**BEFORE THE PUBLIC UTILITY COMMISSION  
OF OREGON**

**UE 394**

In the Matter of	)	
	)	
PORTLAND GENERAL ELECTRIC	)	OREGON CITIZENS' UTILITY
COMPANY,	)	BOARD'S REDACTED EXHIBITS
	)	
Request for a General Rate Revision.	)	
_____	)

Staff of the Public Utility Commission of Oregon (OPUC or Commission) submits these Opening Comments on Portland General Electric's (PGE or Company's) 2019 Integrated Resource Plan (IRP or Plan), filed on July 17, 2019 and Interim Transmission Solution Addendum filed on August 30, 2019. Staff will continue to evaluate the Company's Plan, conduct discovery, and review stakeholders' comments prior to submitting its Final Comments, currently scheduled to be filed on December 3, 2019.

FIGURE 7-13: Cost versus variability for the preferred portfolio

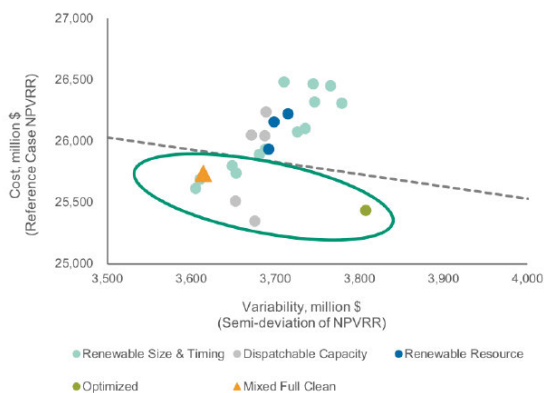
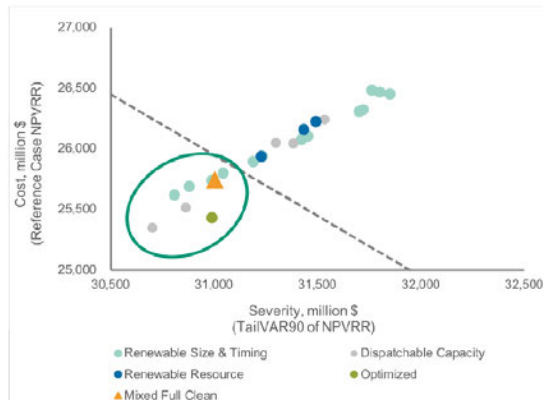
This approach to constructing a new preferred portfolio based on "reasonable actions" from other well performing portfolios is somewhat puzzling, and may present another blunt instrument in portfolio selection. Staff finds this approach particularly curious given that the Mixed Clean Full is outperformed by others in terms of cost and risk, as shown by PGE's graphics:<sup>20</sup>

PGE should provide an analysis comparing its preferred portfolio to other top-performing portfolios for cost and risk, and explain why the Company believes it has chosen a portfolio with the best balance of cost and risk, as required by the IRP guidelines.

**Recommendation 4:** As PGE adjusts its IRP analysis in accordance with Staff's comments, including the removal on non-traditional screens, PGE should provide additional information:

- Provide a quantitative comparison of its preferred portfolio to other well-performing portfolios in terms of NPVRR cost and risk.
- Explain why the Company believes its preferred portfolio has the best balance of cost and risk for customers.

PGE's Intergenerational Analysis<sup>22</sup>

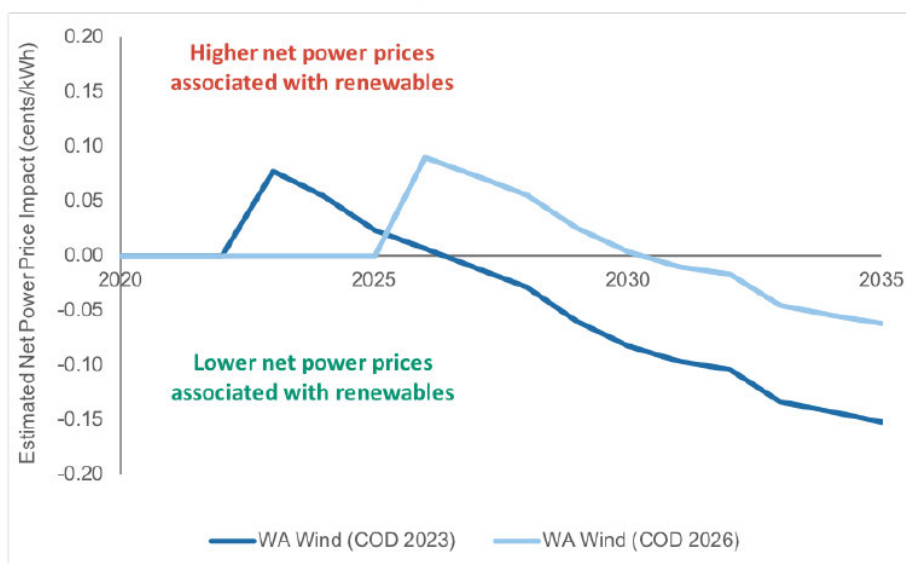
To place additional context on the analysis of a 2026 wind addition, PGE's Appendix G Load Resource Balance indicates that PGE may have an energy deficit by 2025.<sup>23</sup> Staff will conduct additional analysis to consider how the 0.01 cent difference in customer rates compares to the risk of an energy need in 2025, given other assumptions about load growth, voluntary programs, and new Qualifying Facility (QF) contracts that are discussed elsewhere in Staff opening comments.

Many factors could change the effect that a new resource will have on rates, including resource cost and performance, future market conditions, and future customer demand. Staff will continue to assess the inputs and assumptions behind PGE's intergenerational equity analysis. For example, the intergenerational equity analysis may utilize some of the same modeling inputs and assumptions that Staff finds concerning or problematic in the 2019 IRP. Staff hopes PGE will participate in a robust assessment and discussion of the intergenerational equity risks of near-term procurement of renewables.

Electric Vehicle Models Available <sup>58</sup>	
Vehicle Type	2019 Models
Sedan/Wagon	28
SUV	7
Van	2
Pickup	0

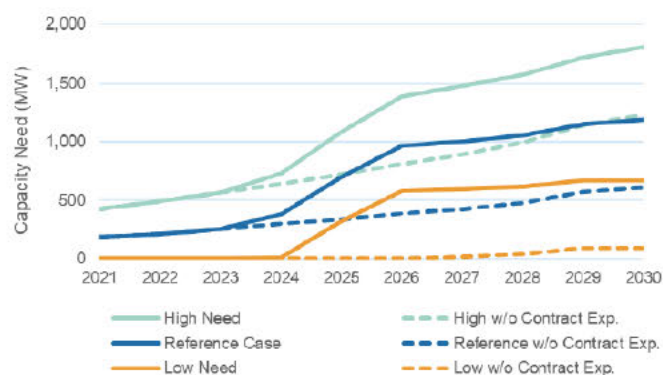
The majority of electric vehicles currently listed in the U.S. Department of Energy Alternative Fuels Data Center's dataset of Alternative Fuel and Advanced Technology Vehicles are sedans and wagons with a small number of sport utility vehicles (SUVs) and vans, and no pick-ups.<sup>57</sup> Given the current nature of the EV market, Staff is concerned that the methodology used in the 2019 IRP overestimates EV load.

**Recommendation 12:** PGE should explain in its reply comments how the Company accounted for consumer vehicle preferences and availability of heavier electric vehicles in its load forecast.

FIGURE 4-17: Load and existing and contracted generation

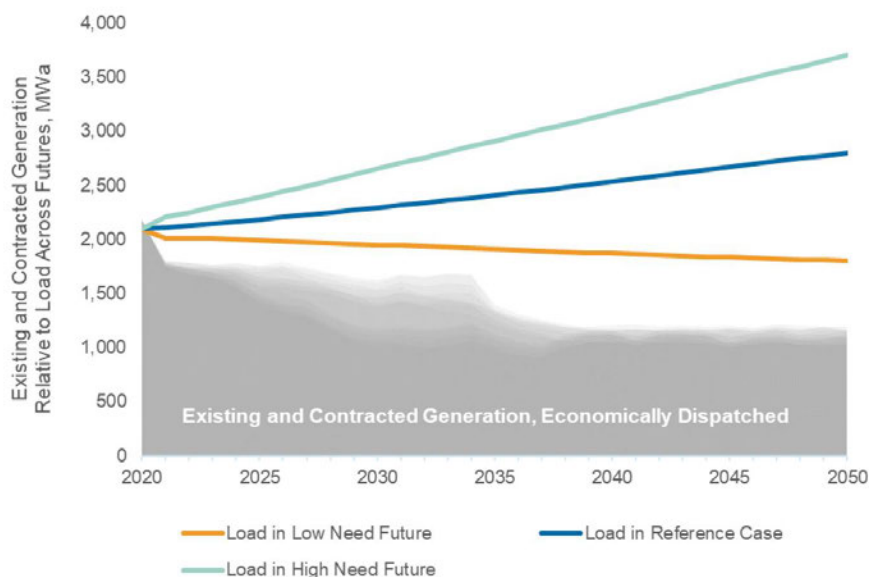
PGE's new market energy position analysis provides an interesting evolution of the Company's traditional load-resource balance. Through this analysis, PGE models economic dispatch and compares it to three need futures to demonstrate what it describes as an "energy shortage" (See Figure 4-17).<sup>66</sup>

Yet, when PGE's resources dispatch economically and market purchases meet the rest of PGE's load, this is not necessarily an indication that PGE needs to acquire more energy resources. It may simply indicate that market prices are low. PGE's 'Market Energy Position' analysis tells how much energy the company may choose to buy on the market, but in no way should it be used to justify any amount of new resource acquisition.

**FIGURE 6-2: Levelized cost of energy (LCOE) of energy resource options**

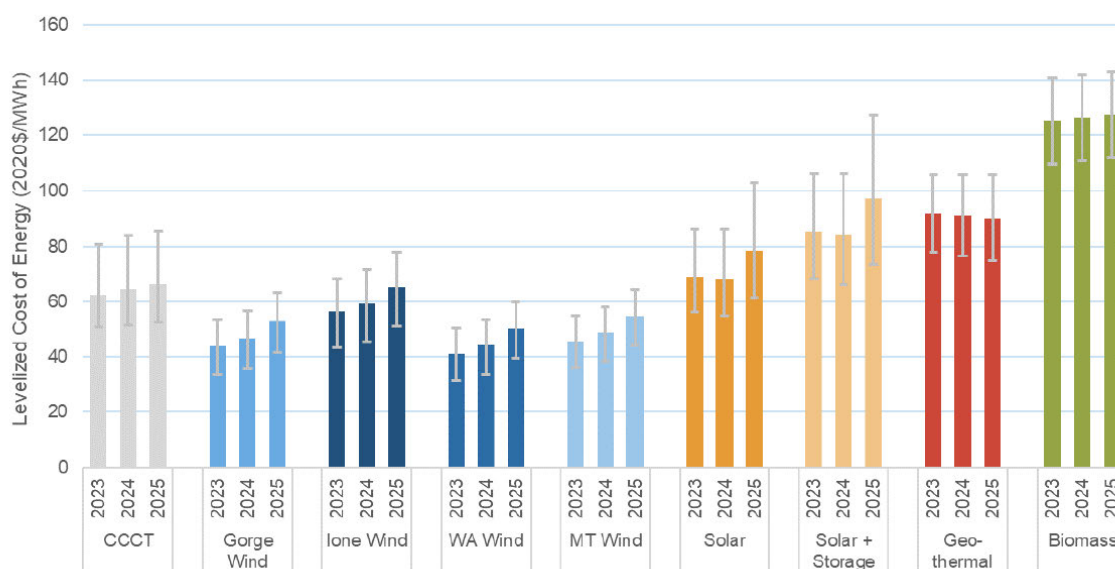
Staff finds this statement generally true and believes the IRP does a good job of demonstrating the production risk associated with capacity factor sensitivity in Section 6.5.<sup>82</sup> However, Staff would like to better understand how the many assumptions underlying this conclusion were captured in the portfolio modeling and selection. Given that the main driver for the near-term acquisition of wind resources is not energy, capacity, or an RPS need, but rather the time-limited economic opportunity associated with expiring PTCs, Staff’s review is focused on understanding the Company’s assumptions around the federal tax incentives and overall performance of renewable energy resources compared to conventional resources (See Figure 6-2 below).<sup>83</sup>

FIGURE 6-15: Net cost sensitivities for wind

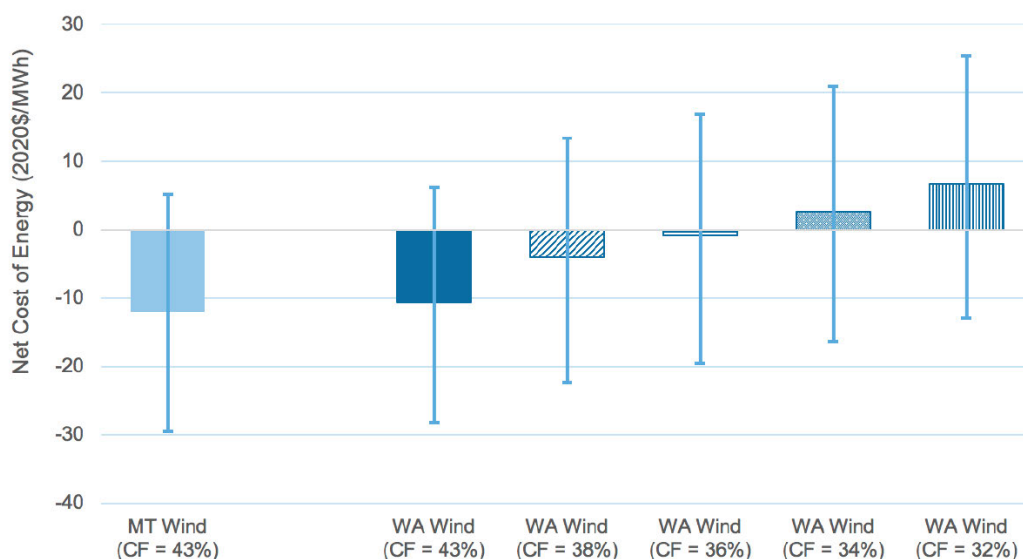
Staff particularly appreciates the sensitivity analysis for wind capacity factors provided in Section 6.5 and Figure 6-15 below.<sup>89</sup>

Staff notes the impact that capacity factor assumptions have on the economic performance of wind resources in PGE's sensitivity and questions whether the Company's sensitivity analysis should have been performed on the Mixed Full Clean portfolio to help characterize the risk of acquiring near-term wind assets based primarily on economic performance.

**Recommendation 20:** Staff requests that PGE provide a sensitivity analysis of the Mixed Full Clean portfolio assuming proportionate changes to the capacity factor of each resource as the assumptions behind the capacity factor sensitivity analysis in Figure 6-15 above.

FIGURE 5-4: Average monthly wind capacity factors by location

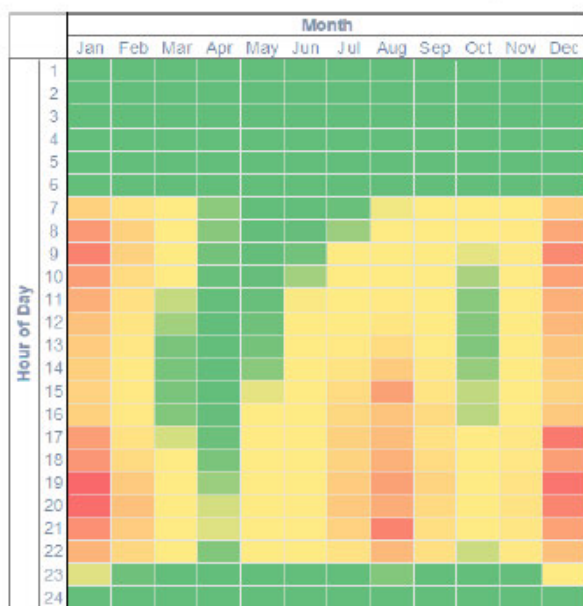
Further, Staff is curious about the relationship between the capacity factor shape of different wind resources modeled in the IRP and PGE's projected capacity needs. For example, PGE provided a helpful characterization of different wind resources' capacity factor shapes in Figure 5-4.<sup>90</sup> Staff notes that the performance of Columbia Gorge and Lone, Oregon wind follow the reverse shape to that of Montana and Washington wind.
